SOUTH HOLLAND DISTRICT COUNCIL

Refusal of Planning Permission

Reference: H16/0542/92 Received:15-MAY-92 Type:FULL

Description: Erection of pair of 2 bedroomed semi-detached houses
Location : 22 Wygate Road Spalding
Lincs

Block plan 1:200

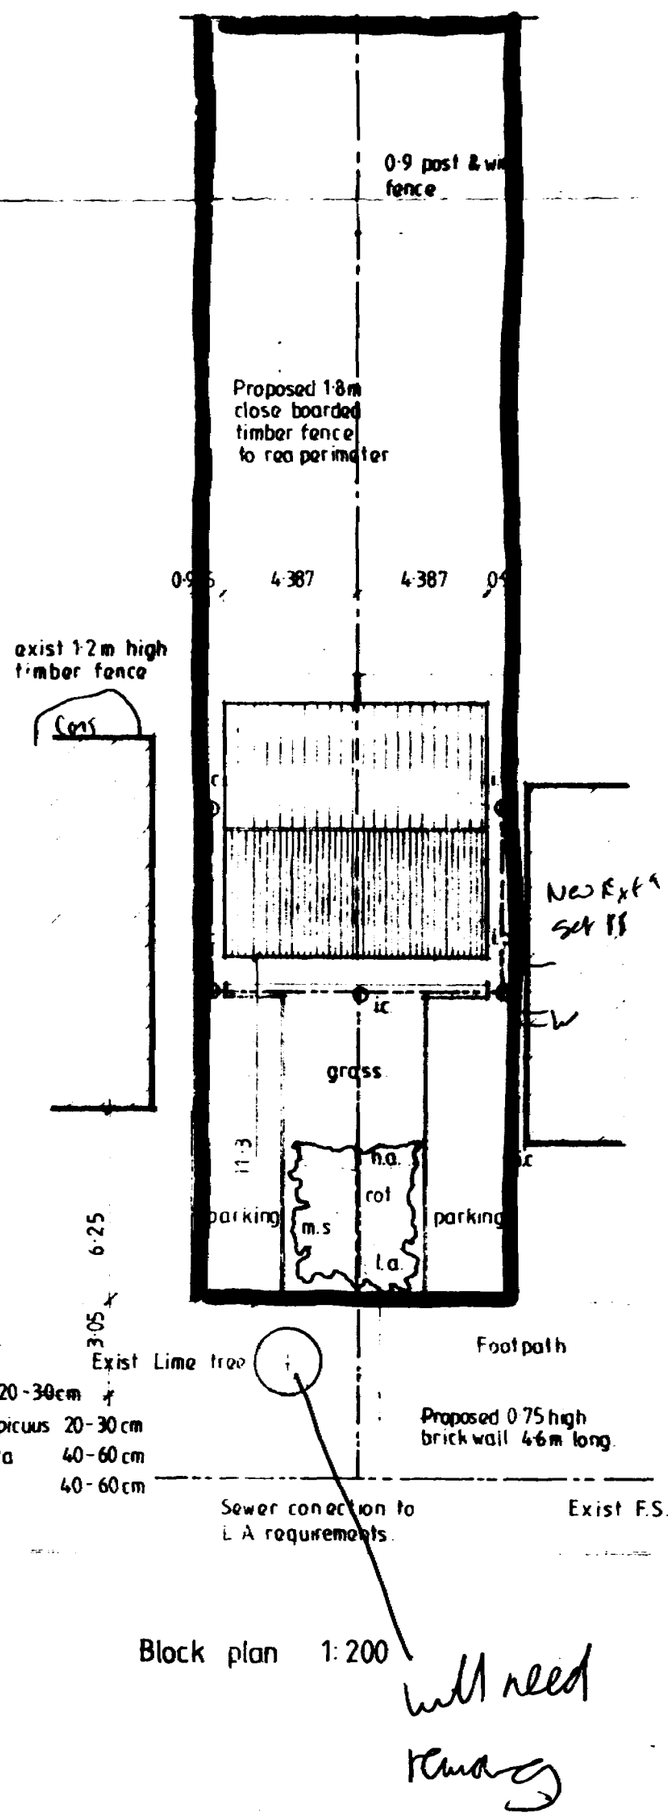
1 The proposed development is only 1.825 metres less in width than the site. This results in the parking arrangements being at the front of the site which emphasises its cramped appearance.

2 The proposal would require the removal of a tree in the highway verge, which would harm the visual amenities of the area.

will need revising
